**RE: UTILITY IMPROVEMENTS – PHASE III
 ELKTON, SOUTH DAKOTA
 SPN #16409**

ADDENDUM NUMBER 1

SECTION VIEW OF TYPE C WALL
MONOLITHIC WITH VALLEY GUTTER

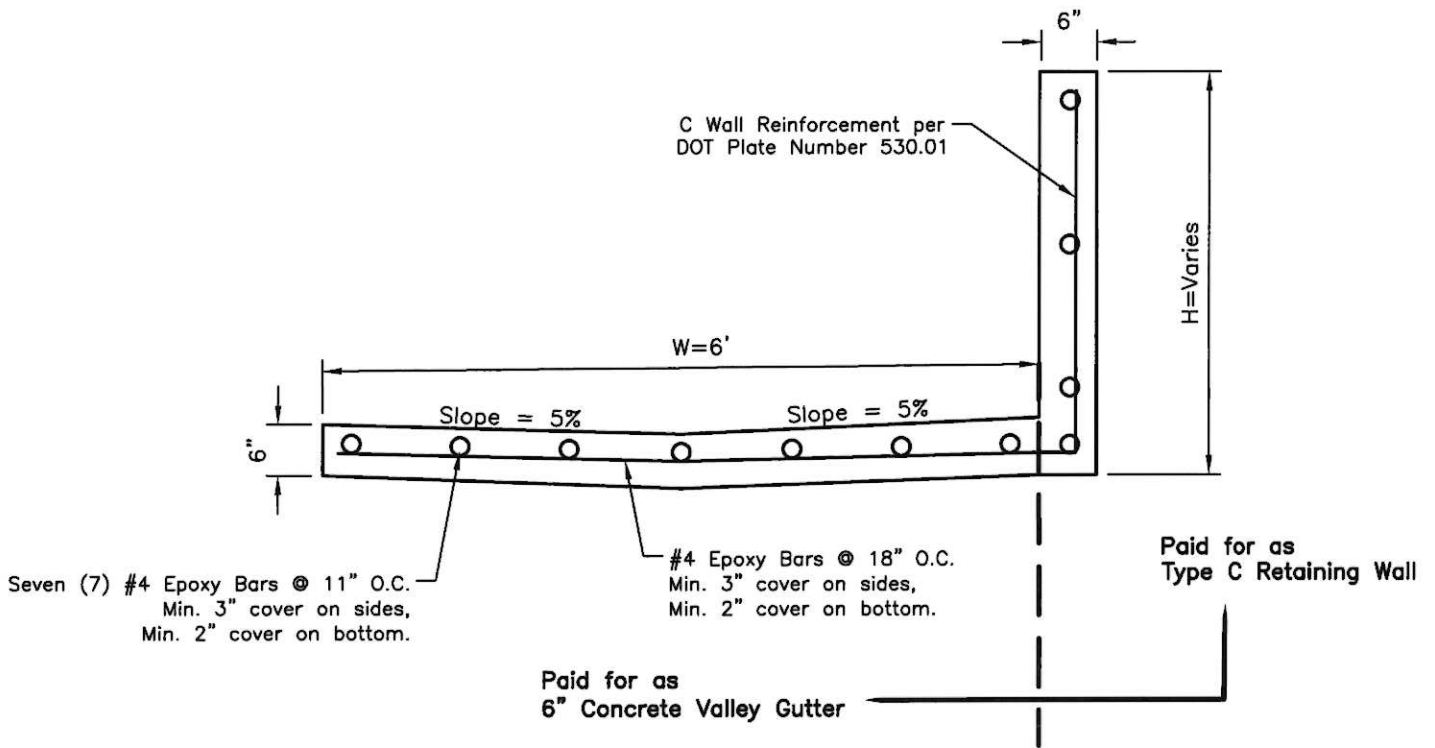
The attached detail is provided to clarify payment for the Type C Concrete Retaining Wall.
